**Subject: Beaver Valley Power Station, Unit No. 1
BV-1 Docket No. 50-334, License No. DPR-66
Additional Information Regarding Responses to RAI Dated July 28,
2005 in Support of License Amendment Request No. 320**

UPDATED RESPONSES TO RAI QUESTIONS B.1 AND C.5

UPDATED RESPONSES TO RAI QUESTIONS 5 AND 6

Figure 5-1
Pressurizer Level

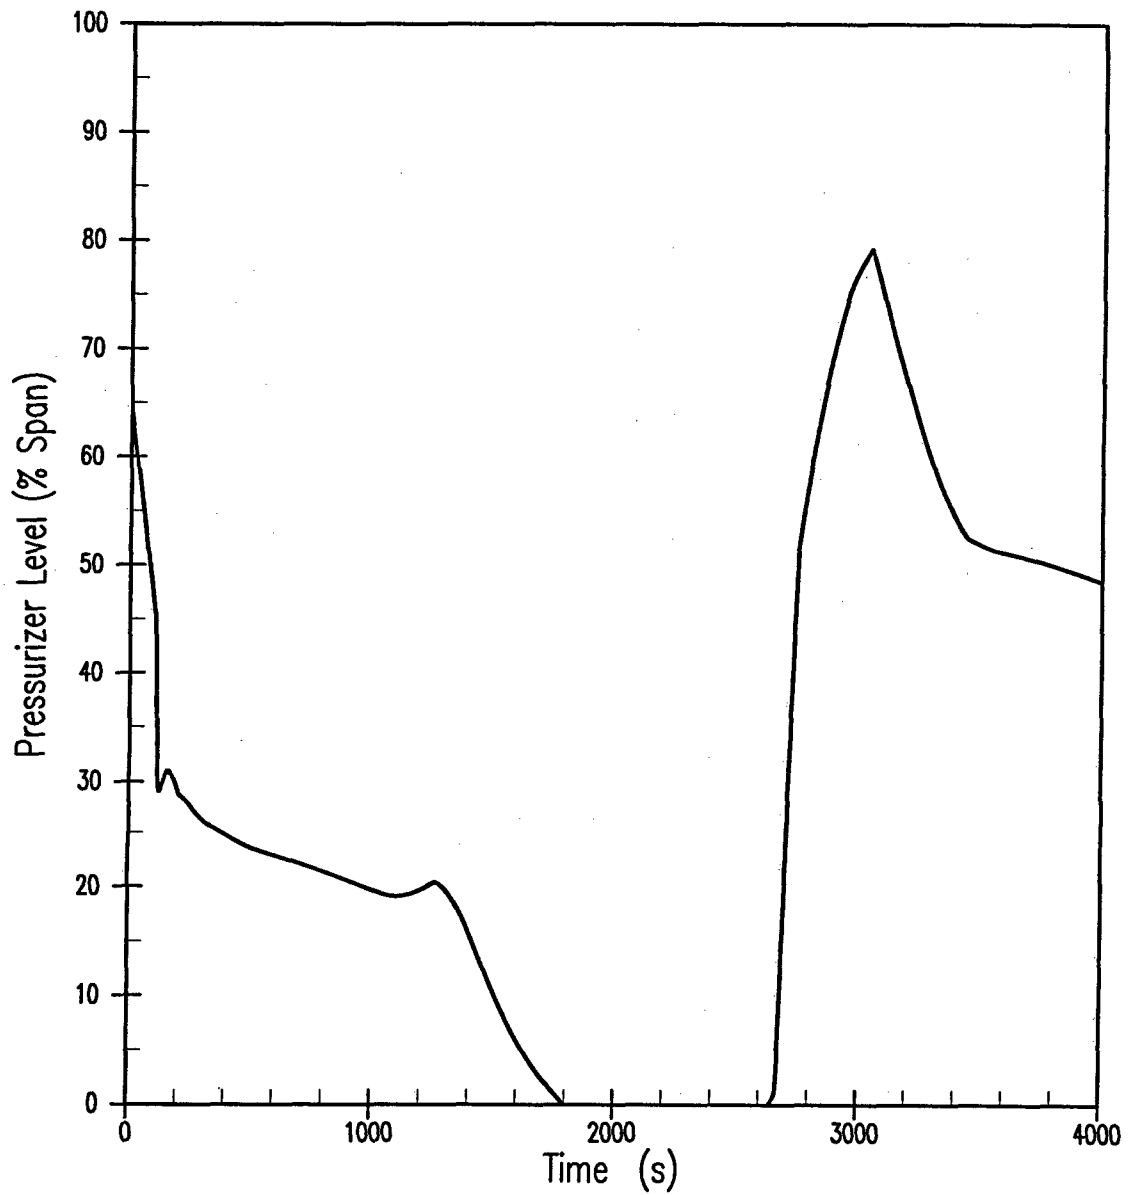
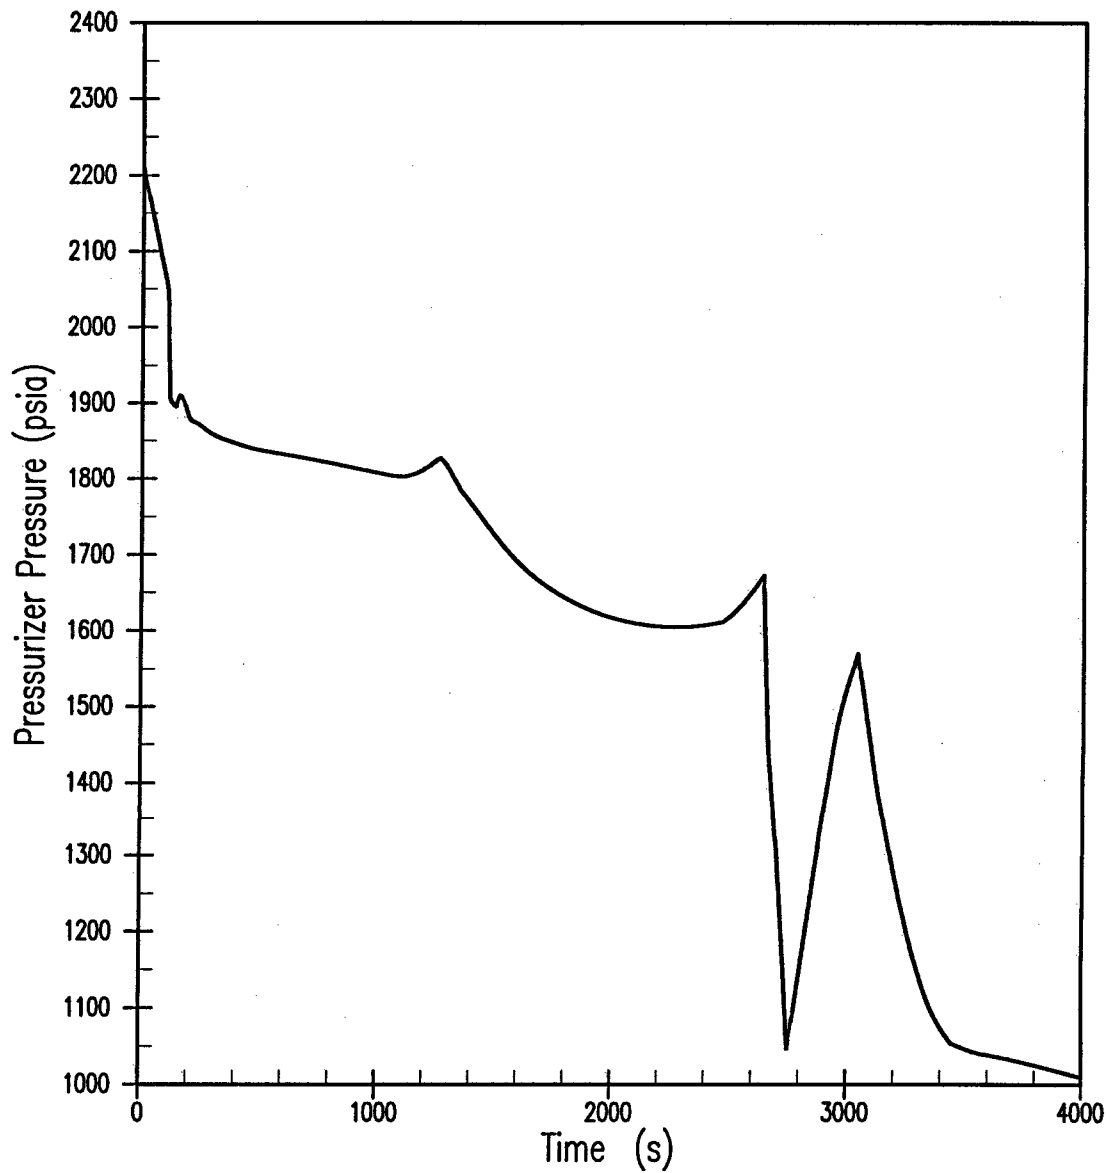
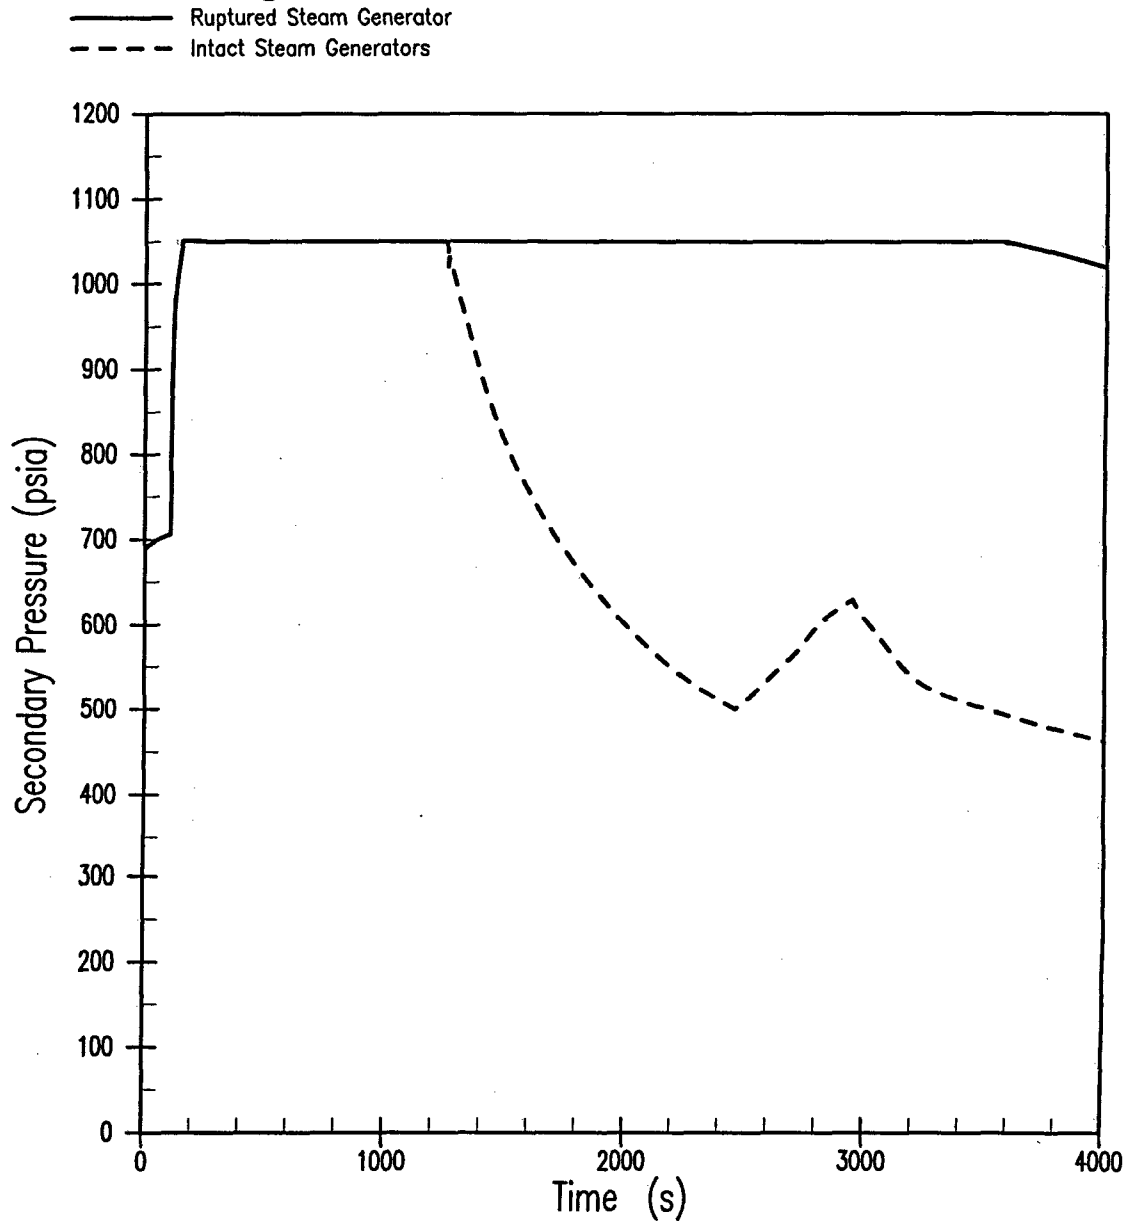
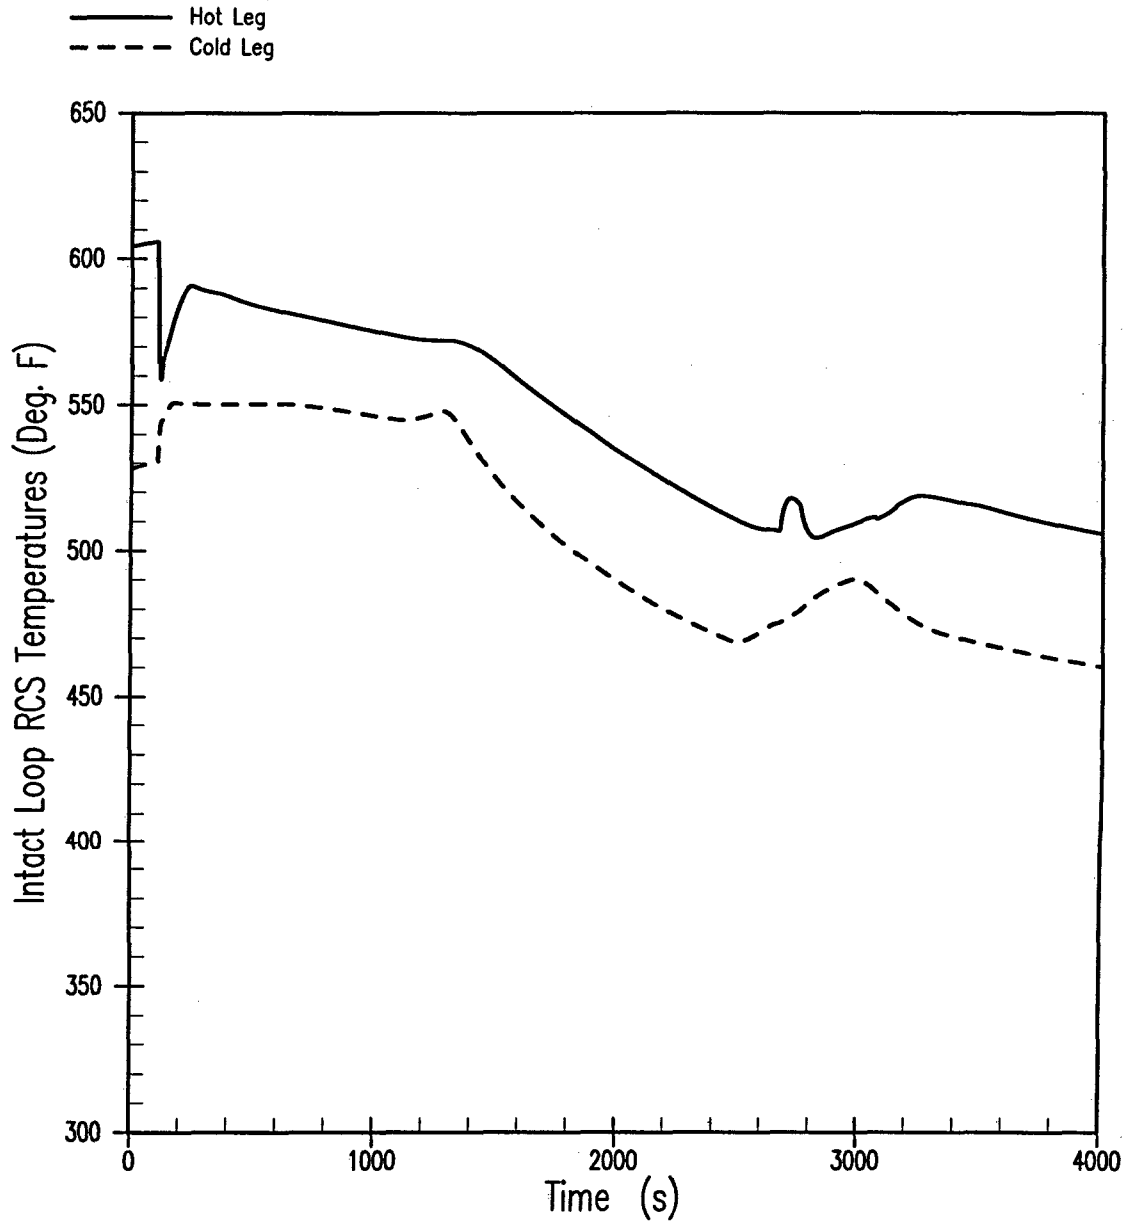
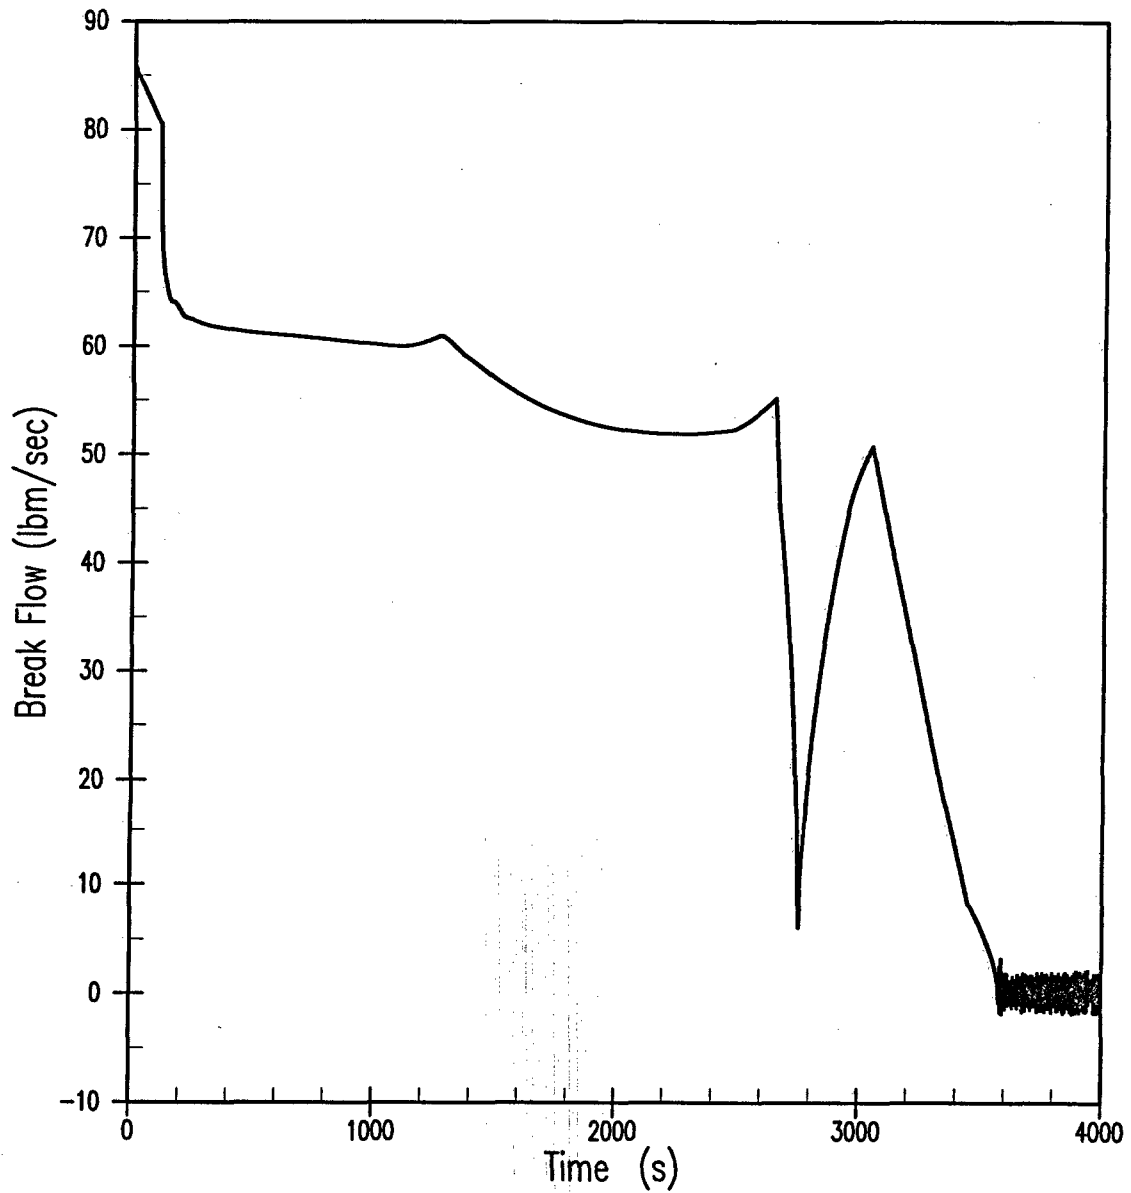
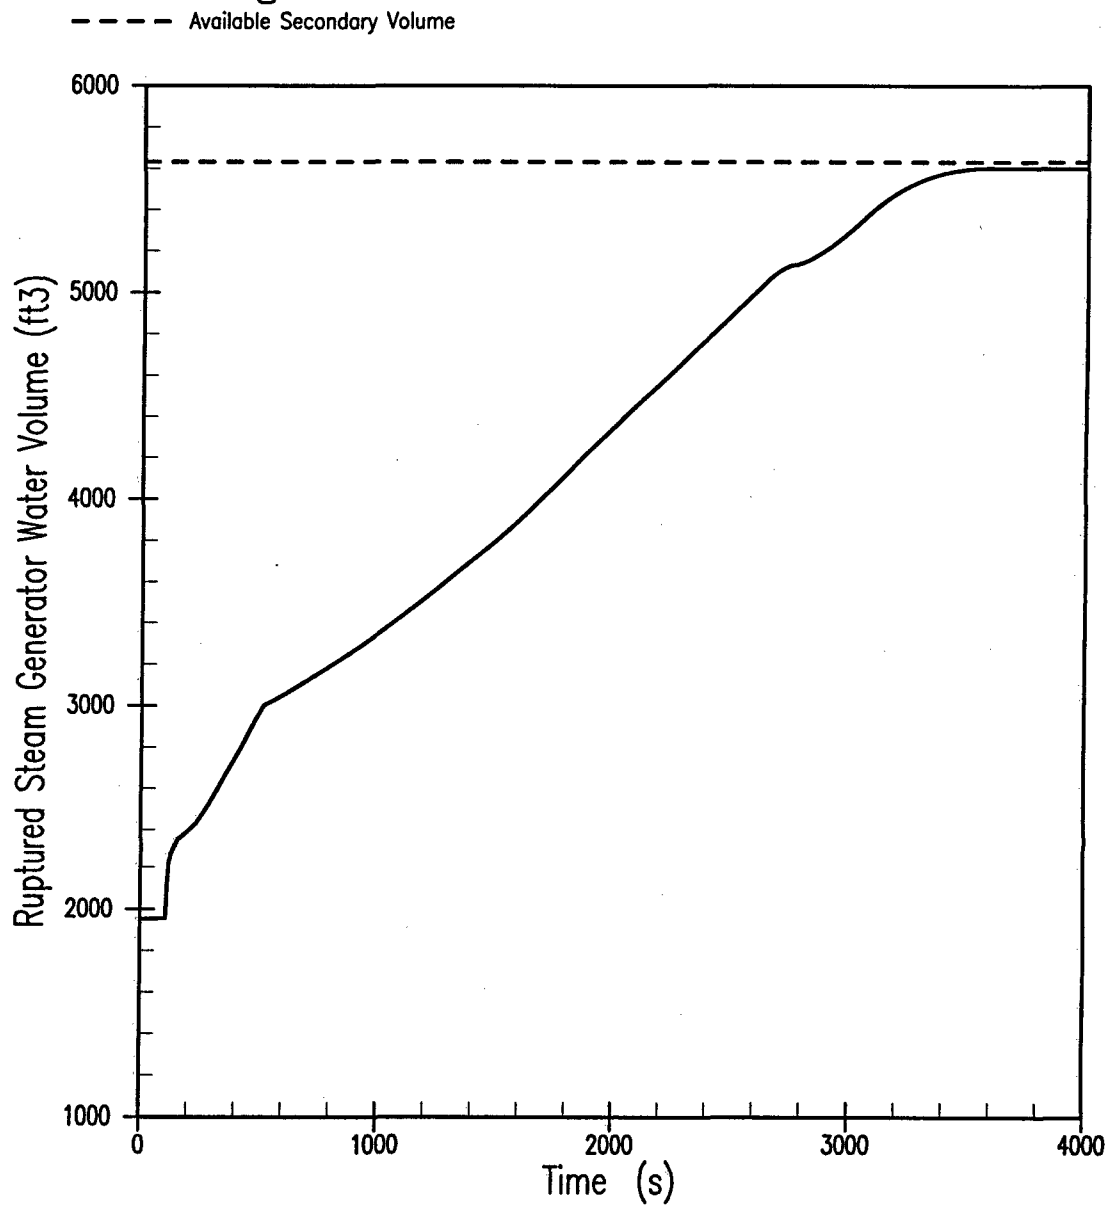
Section 5.4 of the April 13, 2005, RSG LAR states that an operational response analysis of steam generator tube rupture (SGTR) was performed for BVPS-1. The NRC staff requests that the licensee provide a table listing the sequence of events and times from break initiation to event termination that shows operators can terminate the break flow from the ruptured SG within 51 minutes of accident initiation for the SG replacement and extended power uprate (EPU) conditions. Additionally, the staff requests that the licensee provide the results of the SGTR thermal-hydraulic analysis over time showing the pressurizer pressure, intact and ruptured SGs pressures, and ruptured SG water volume for the analysis to demonstrate that no overfilling of the SG occurs.

Updated Response (*with changes from previous response provided in italicized bold type*):
Note, there were no changes to Table 5-2 or to the Figures 5-1 through 5-6. They are being provided for completeness.

The SGTR operational response analysis for EPU conditions with RSG included cases to provide thermal-hydraulic tube rupture data for use in radiological dose consequence analysis and for evaluation of margin to overfill. The sequence of events for these cases is shown in Tables 5-1 and 5-2, respectively. The sequence of events tables show that termination of the event (i.e., termination of primary-to-secondary break flow) occurs at **3988** seconds (approximately **66.5** minutes) and 3578 seconds (approximately 60 minutes), respectively, for EPU conditions with RSGs. ***For BVPS-1, the termination time used in the radiological dose consequence analysis was increased to allow additional operator action time for the operator to isolate the failed-open steam generator atmospheric dump valve (ADV) on the ruptured steam generator.*** Figures 5-1 through 5-6 show the response of pressurizer level, pressurizer pressure, intact and ruptured SG pressure, intact loop RCS temperatures, primary-to-secondary break flow, and ruptured SG water volume for the margin to overfill case. The response to Question 6 provides information regarding the analysis performed in the 1990's for current power conditions that established a break flow termination time of 51 minutes.
